# PERMIT

SEWAGE DISPOSAL SYSTEM

HOWARD COUNTY HEALTH DEPARTMENT

SUBDIVISION \_\_\_\_\_ LOT \_\_\_\_\_ ROAD 14718 Dorsey Mill Road

SITE PLAN  
 14718 DORESY MILL RD  
 DISTR. HO. CO. MD.  
 JUNE 4, 1998 SCALE 1"=40'

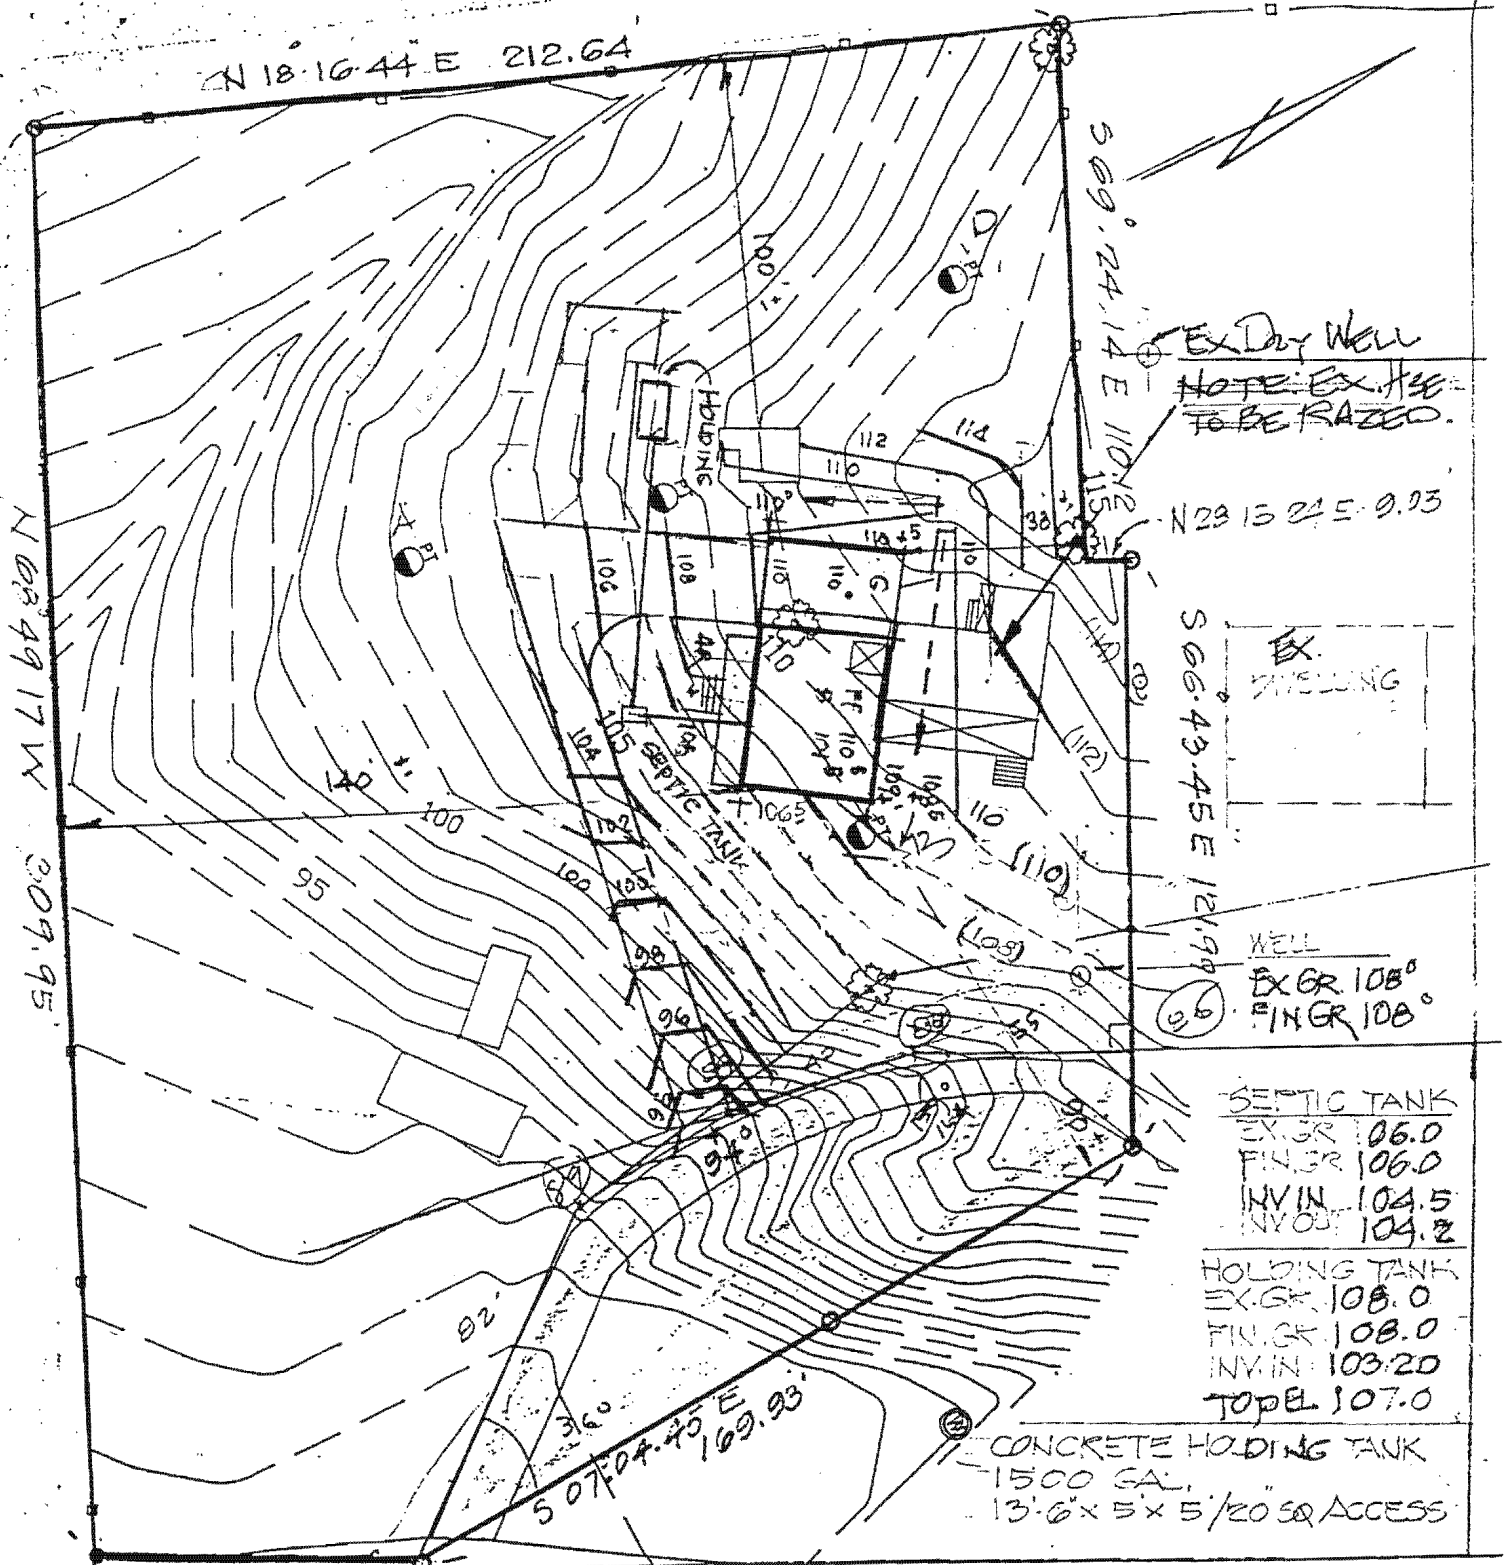
LOCATION - Place the holding tanks 65 feet off the 121.99' lot line and 150 feet off the rear (309.95') lot line as seen from the access off Dorsey Mill Road.

**SITE PLAN - 14718 DEKSEY MILL ROAD, HOWARD CTY, MD 21738**

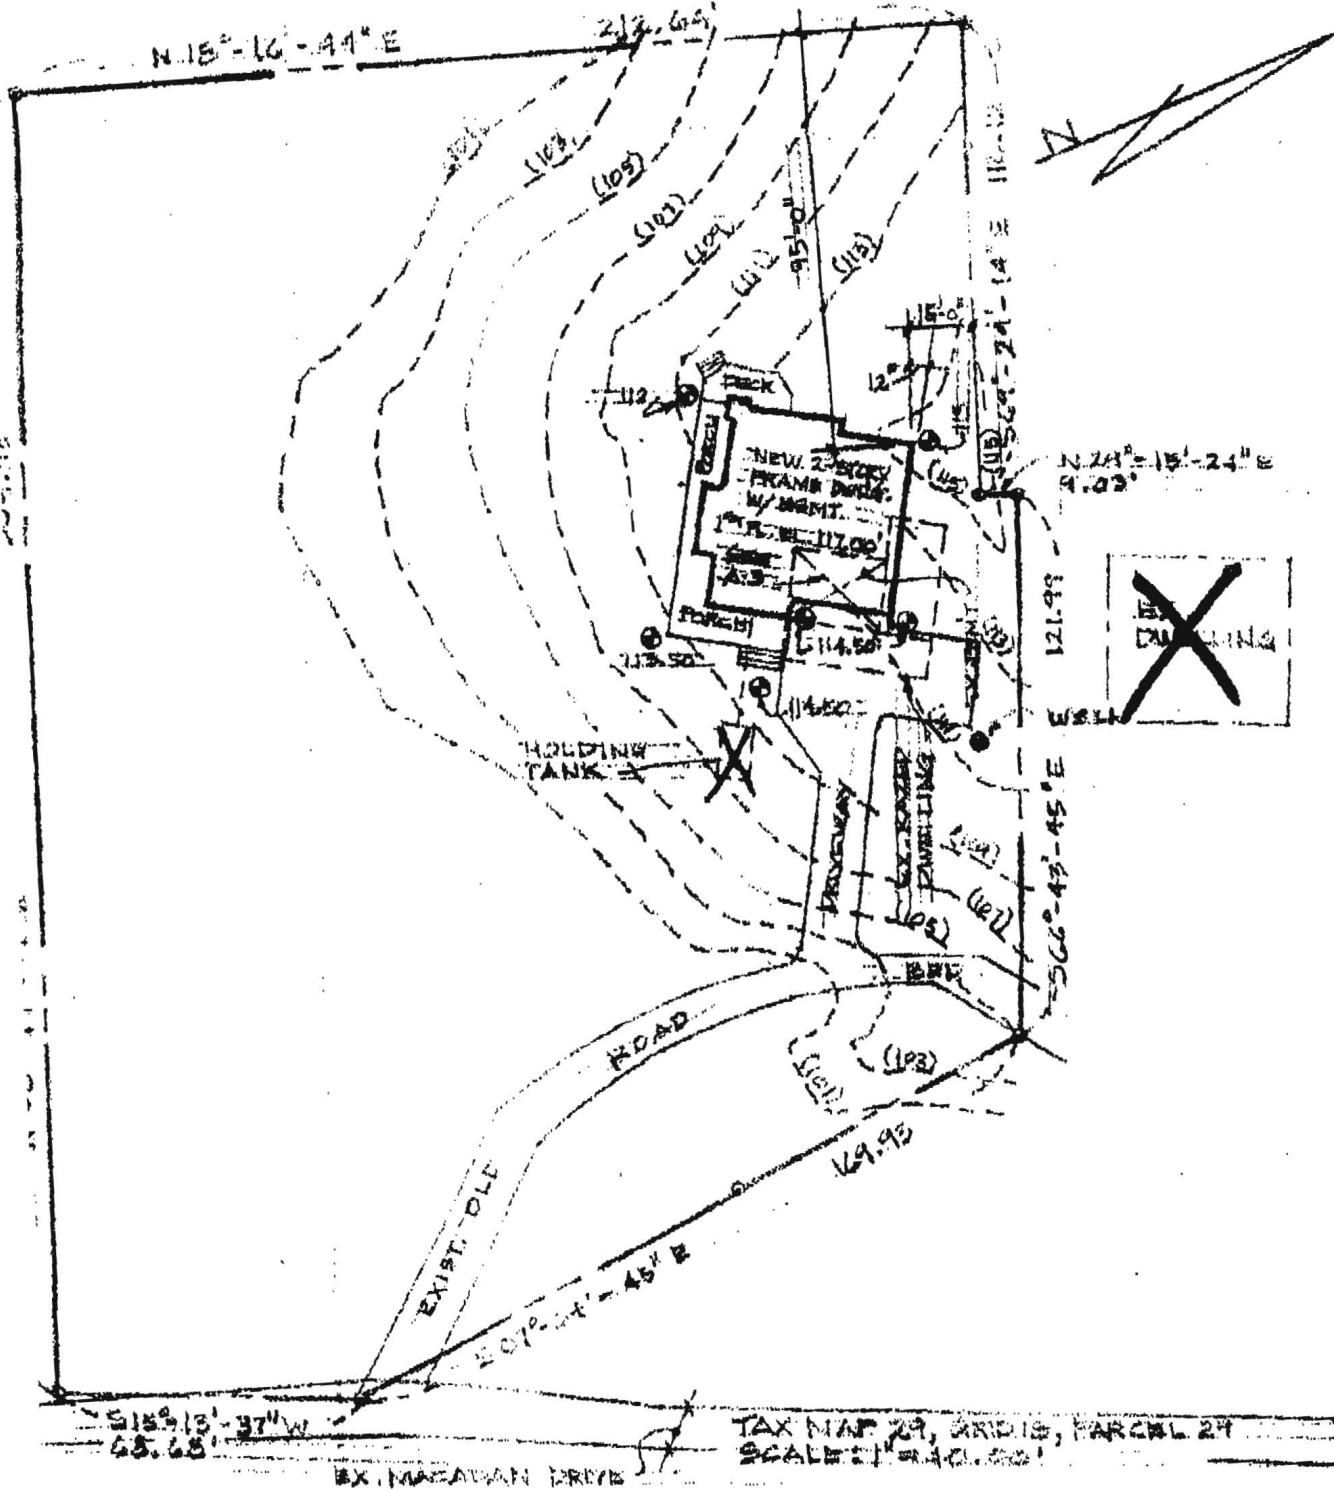
Comments rite plan Dorsey Mill rd  
- well + stream + house setbacks need  
to be maintained - possible area ~~circled~~  
circled in dark black.
